INTERSTATE ROUTE H-1
ADDITION AND MODIFICATION OF FREEWAY ACCESS
(Kapolei Interchange Complex), Phase 3
Federal Aid Project No. NH-H1-1(271)

SHEET No. R-15 OF 167 SHEETS

GUARDRAIL DETAIL AND NOTES

Date: August 2022 R-16 OF 167 SHEETS SHEET No.

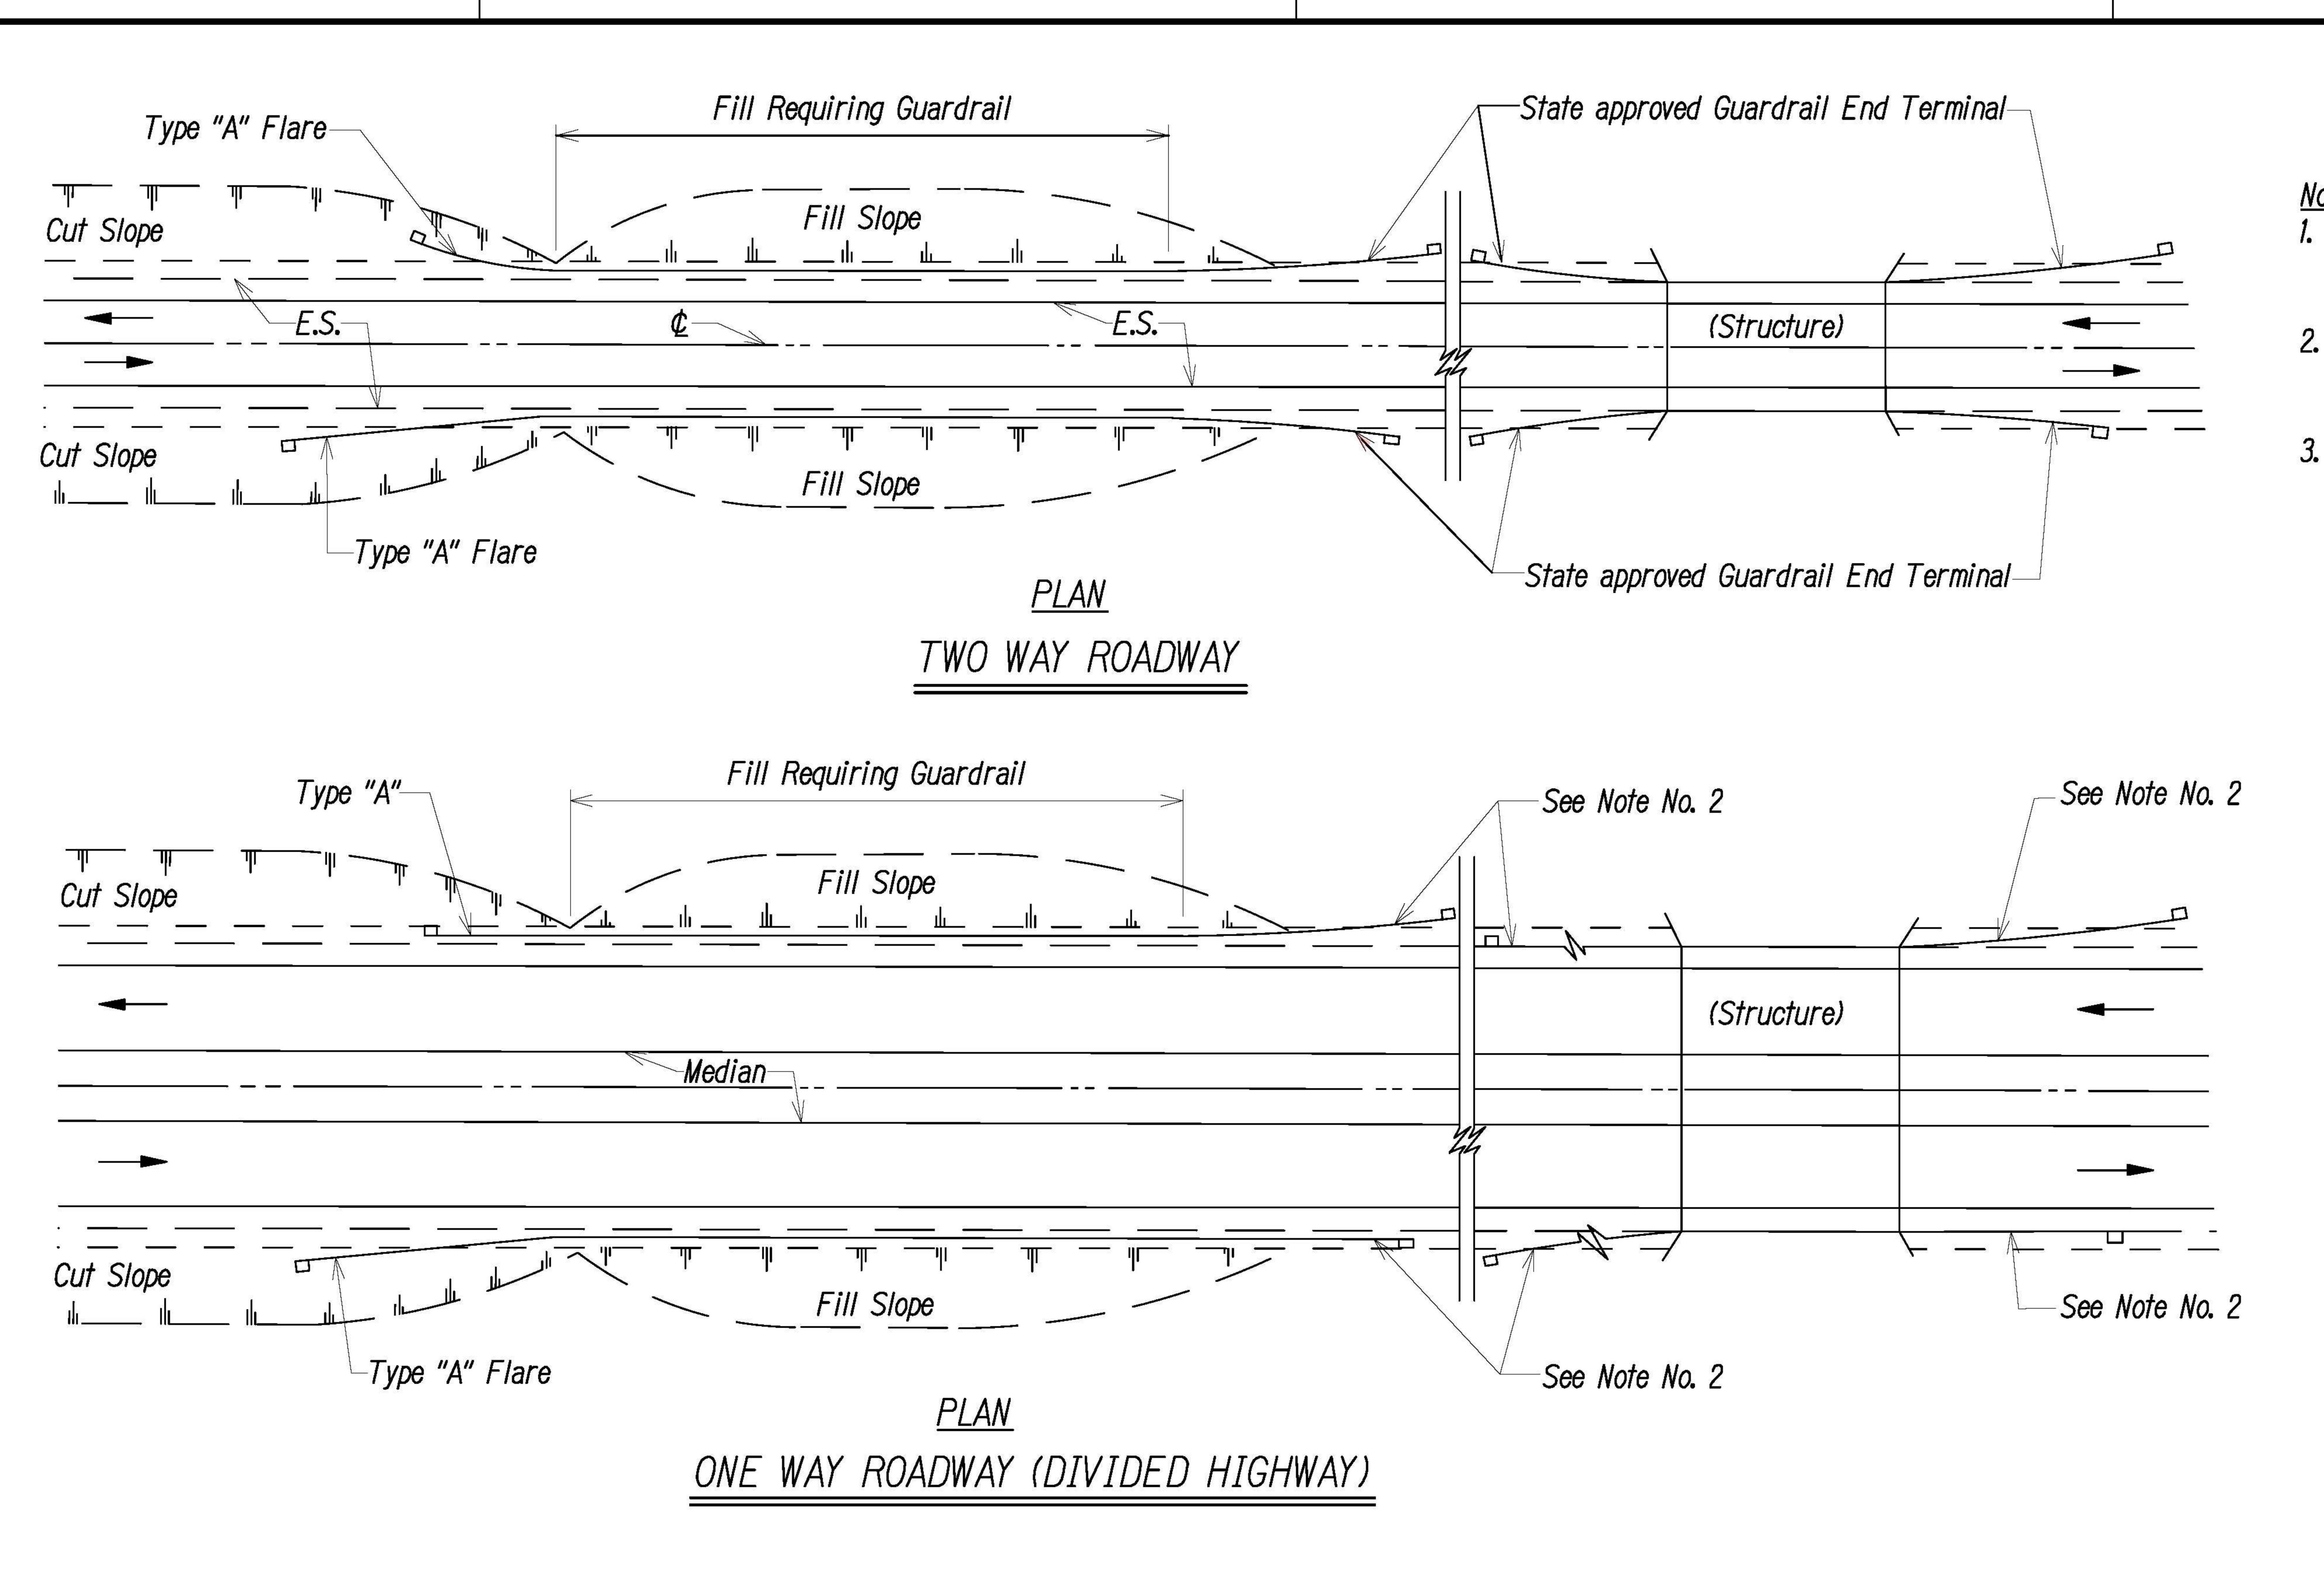
approved sheet and added 6" 10/21/2022 Aggregate Subbase STATE OF HAWAII DEPARTMENT OF TRANSPORTATION HIGHWAYS DIVISION

GUARDRAIL DETAILS 1 INTERSTATE ROUTE H-1

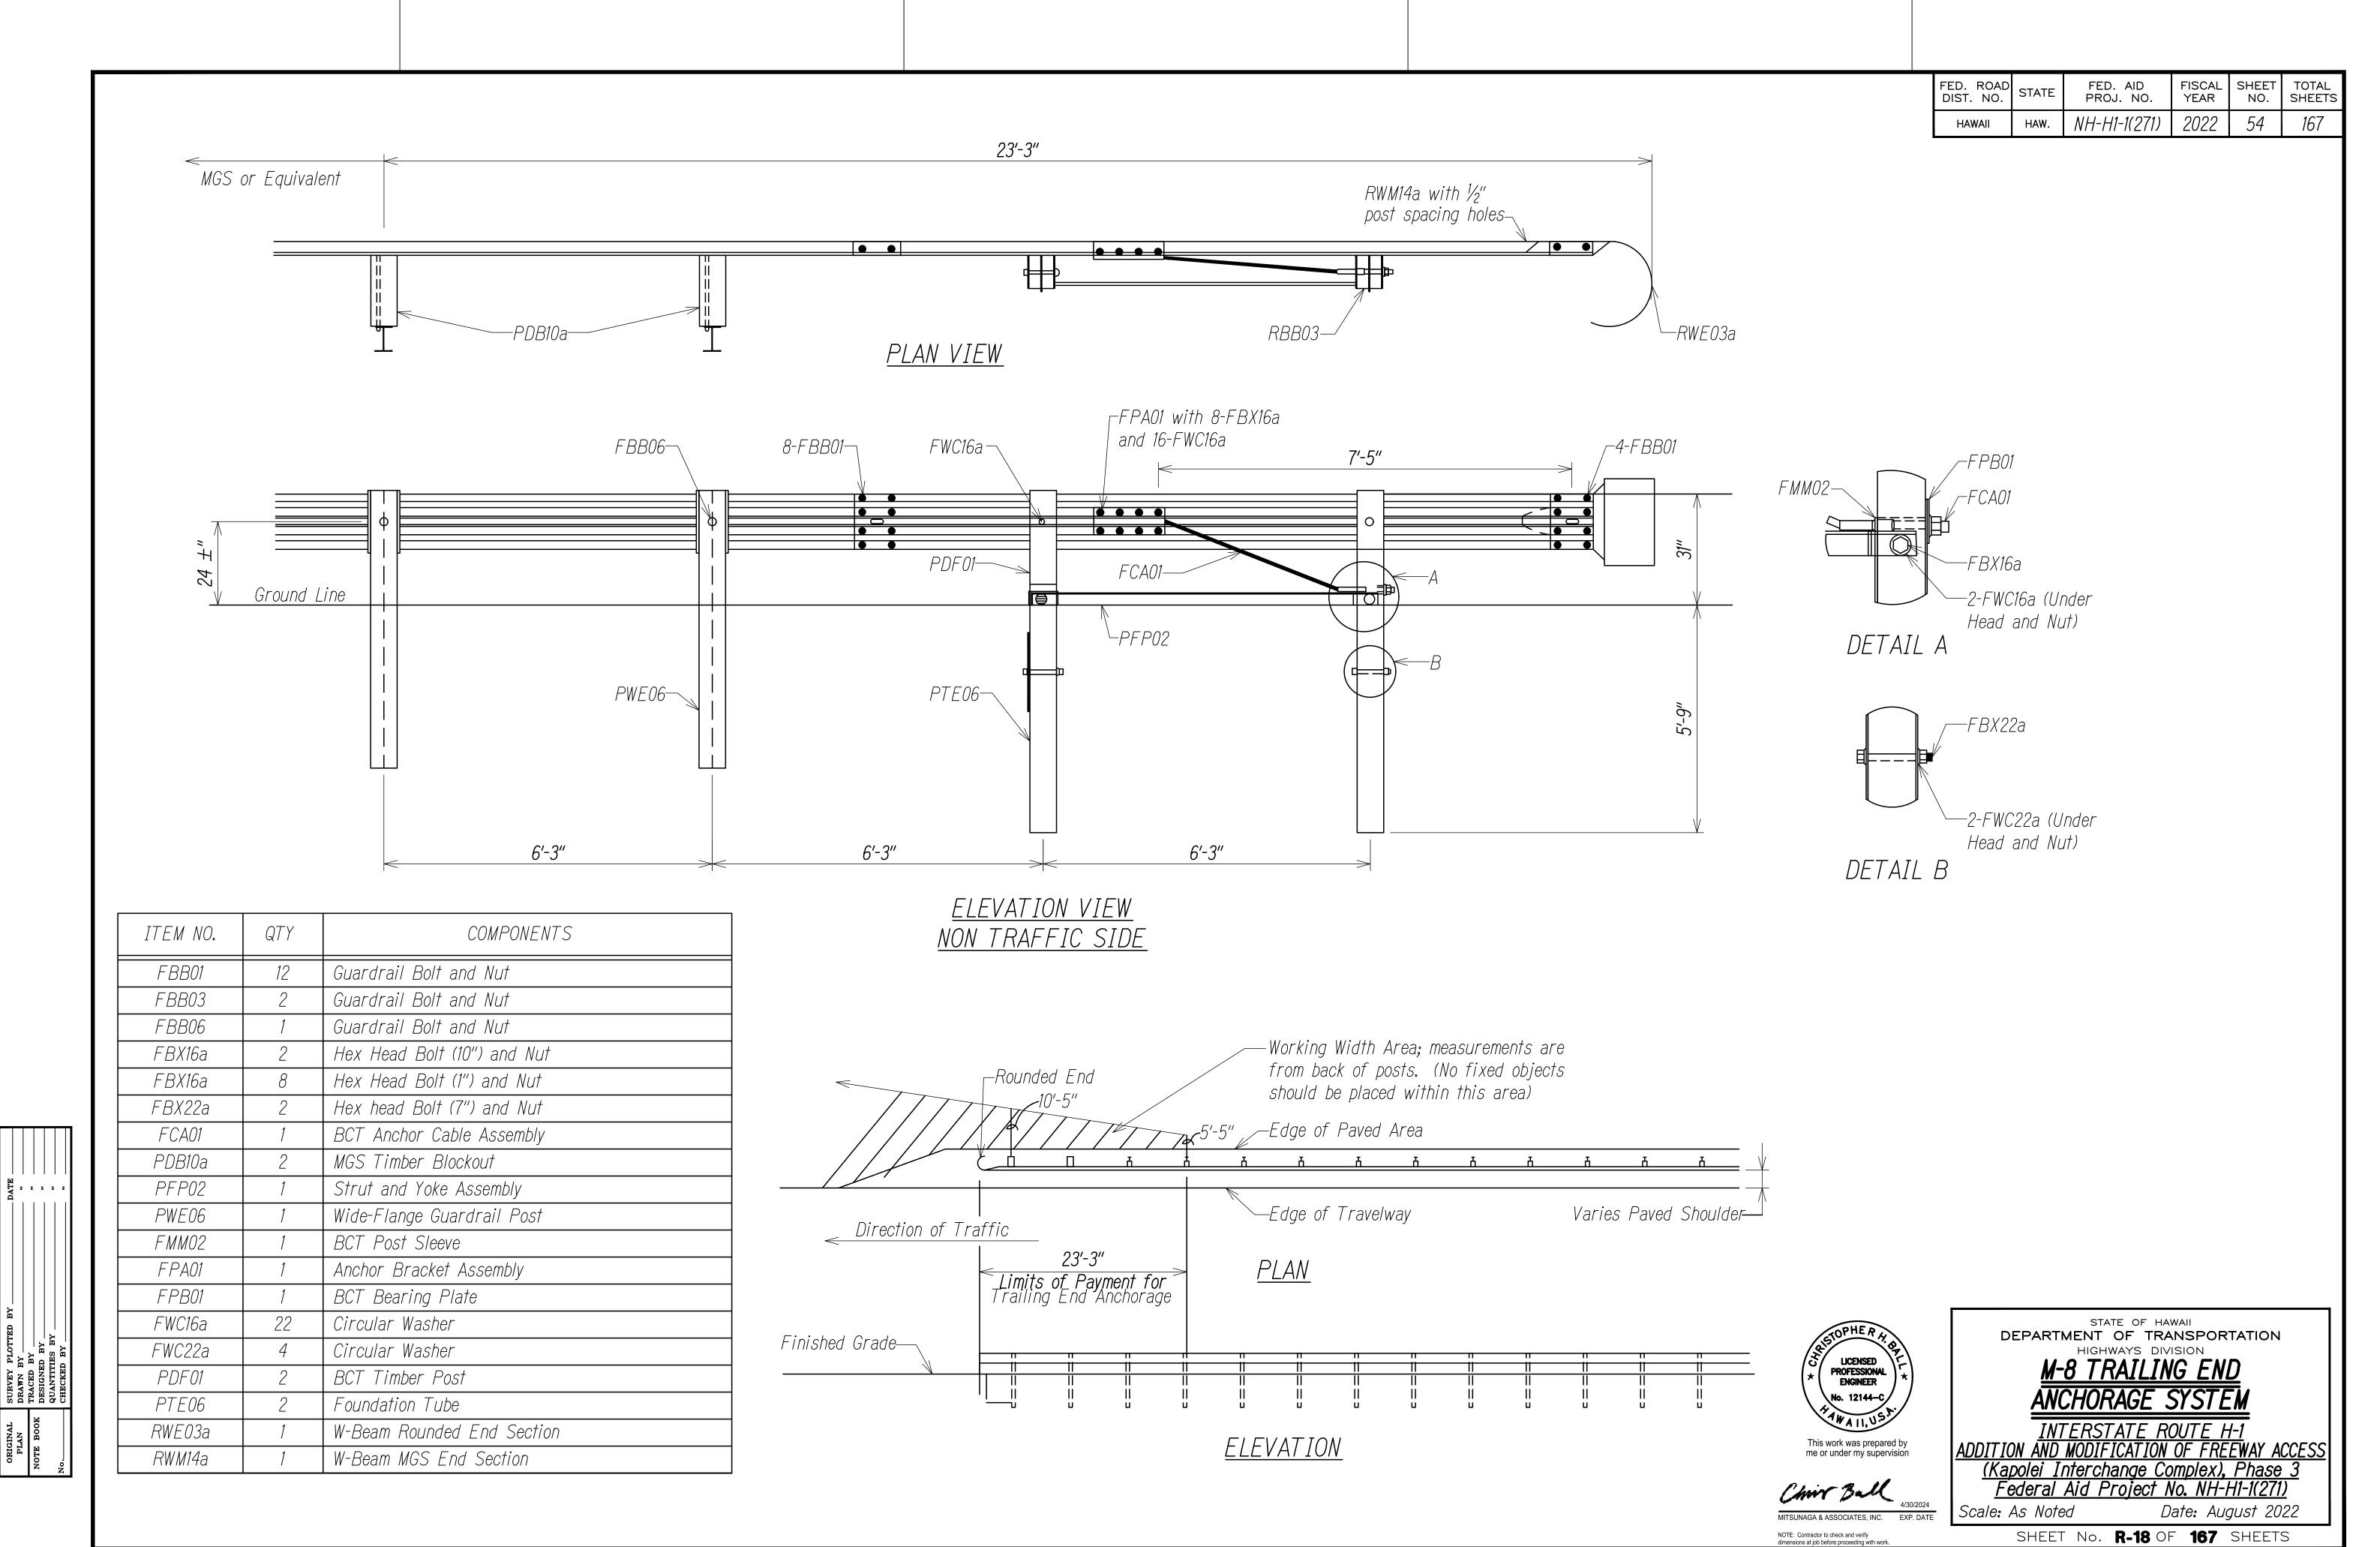
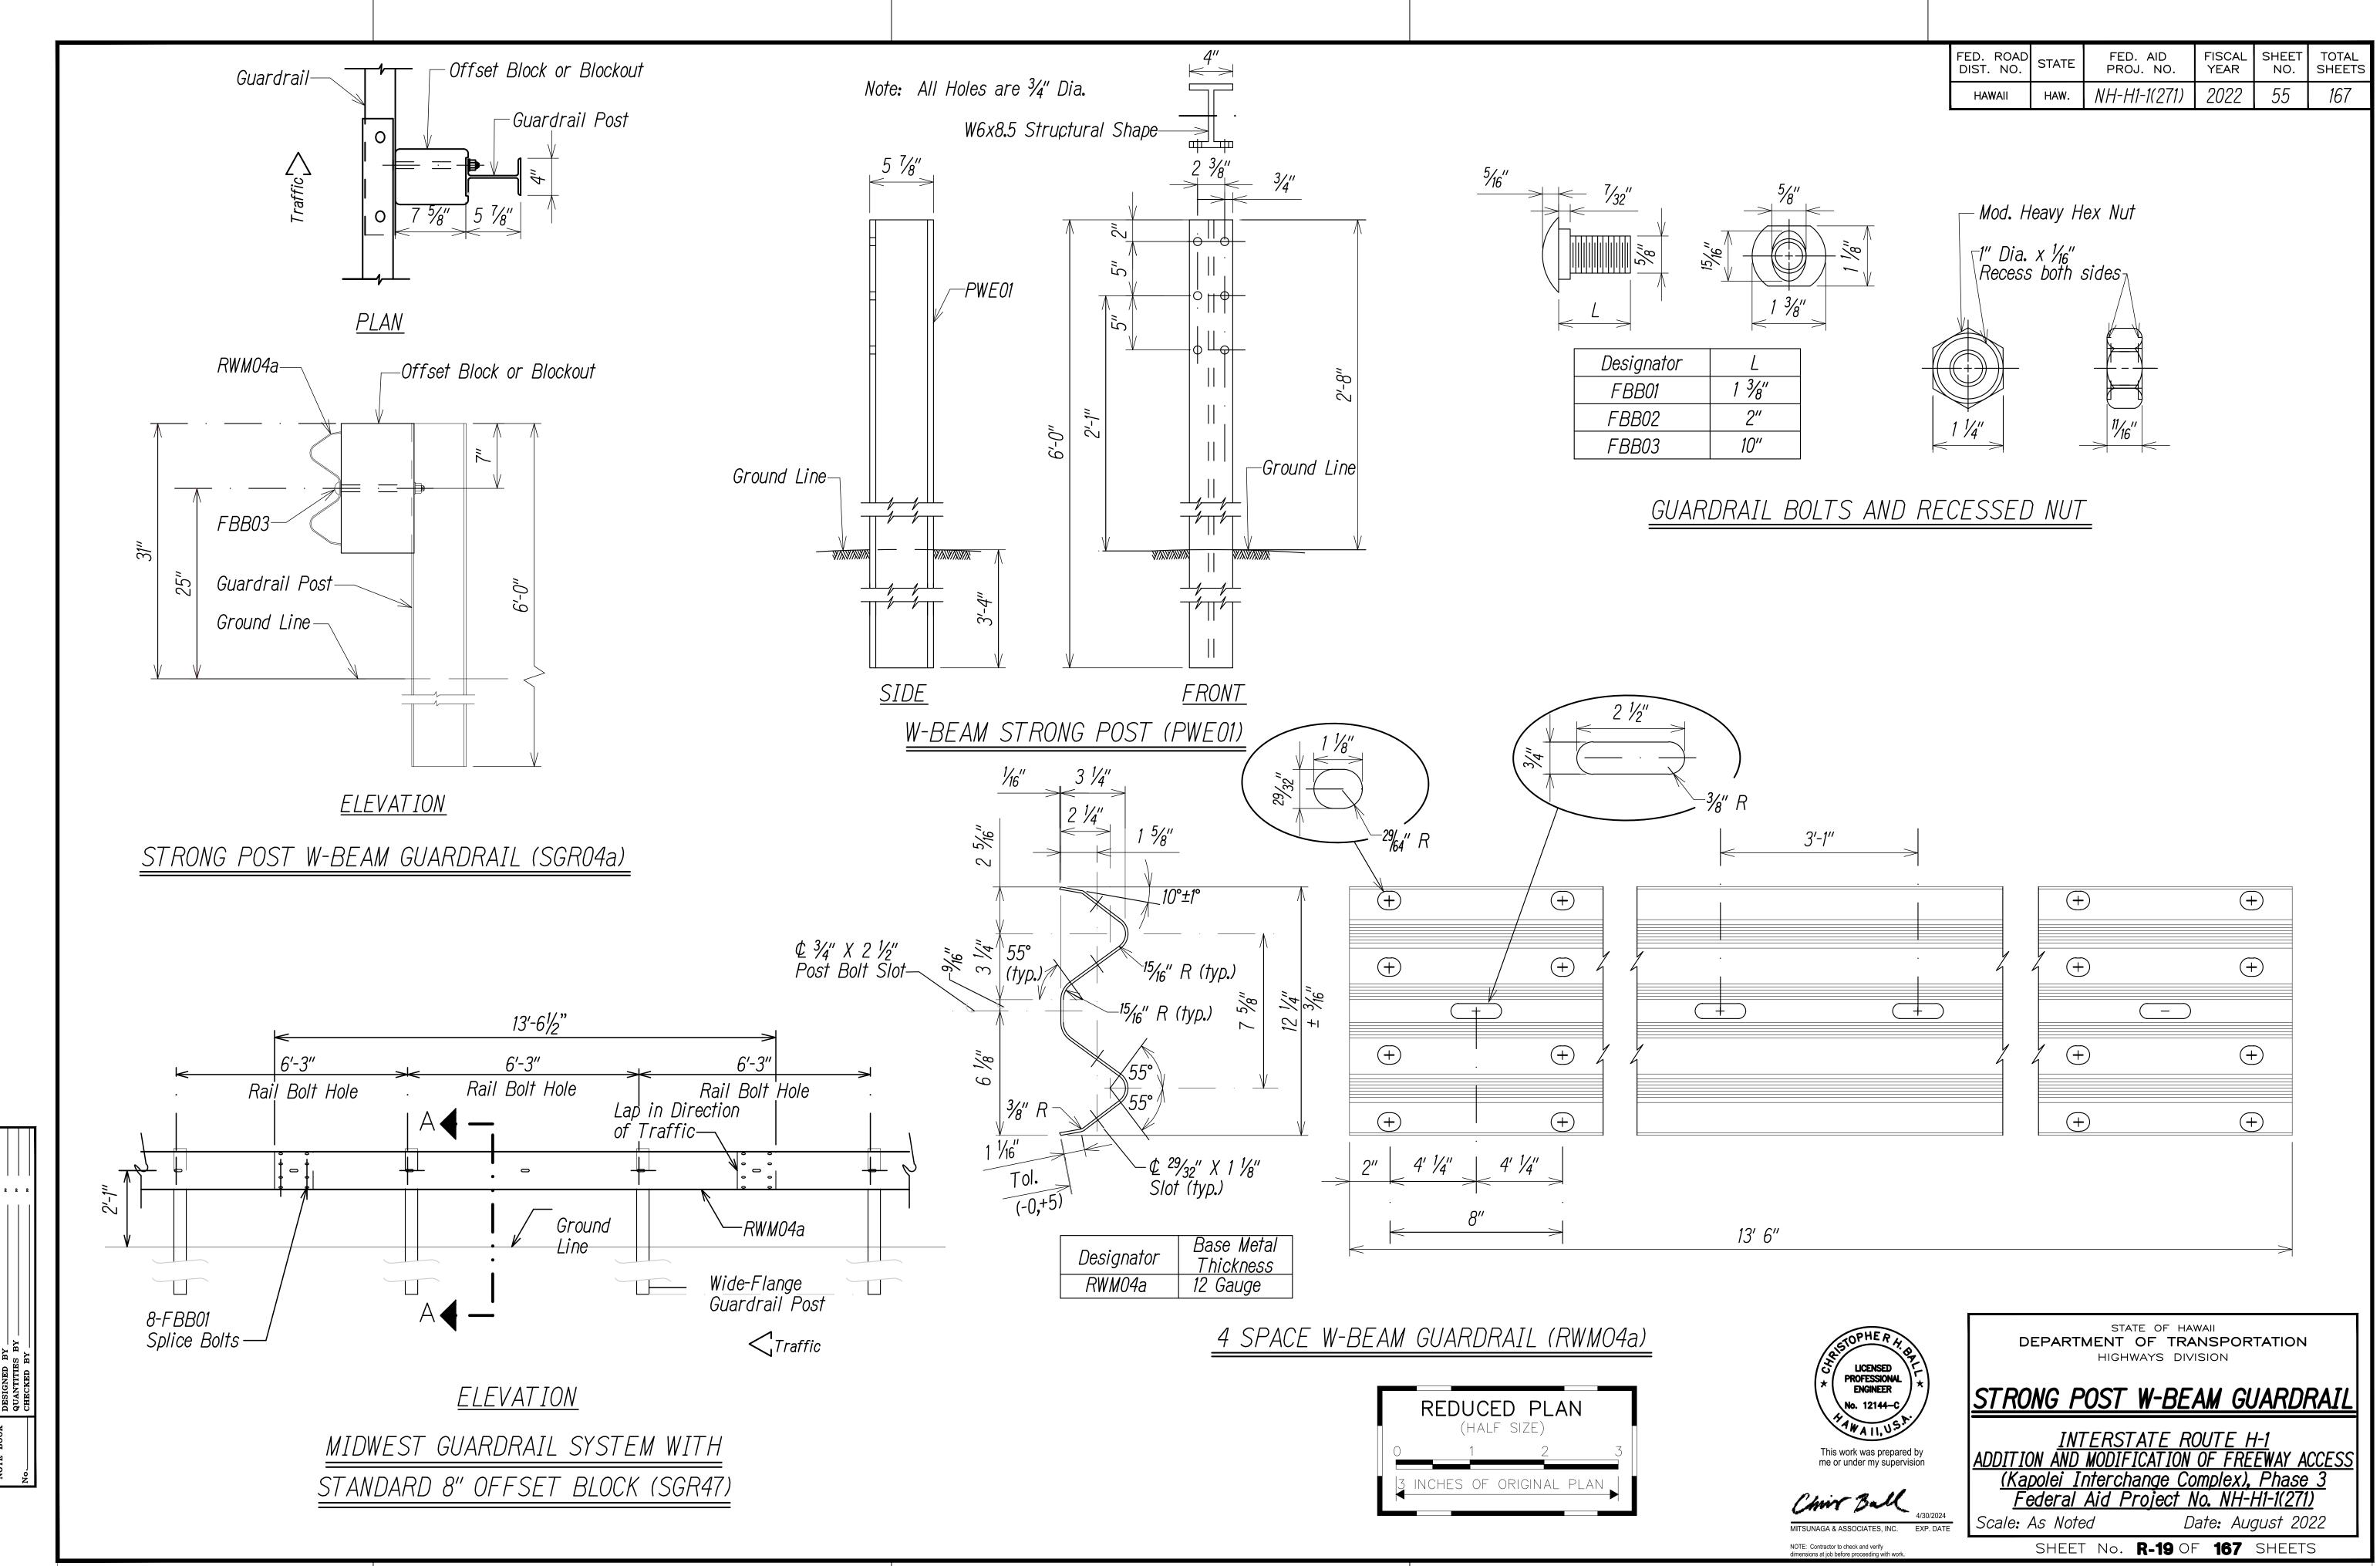
10/21/2022 Revised note 3 to MASH

- Metal Guardrail connection to concrete structures requires End Post Connection. See Structure Plans.
- 2. Depending on the existing field conditions, the Engineer shall determine which guardrail end terminal should be installed.
- 3. Refer to State's most current approved Product List for MASH approved Guardrail End Terminals.
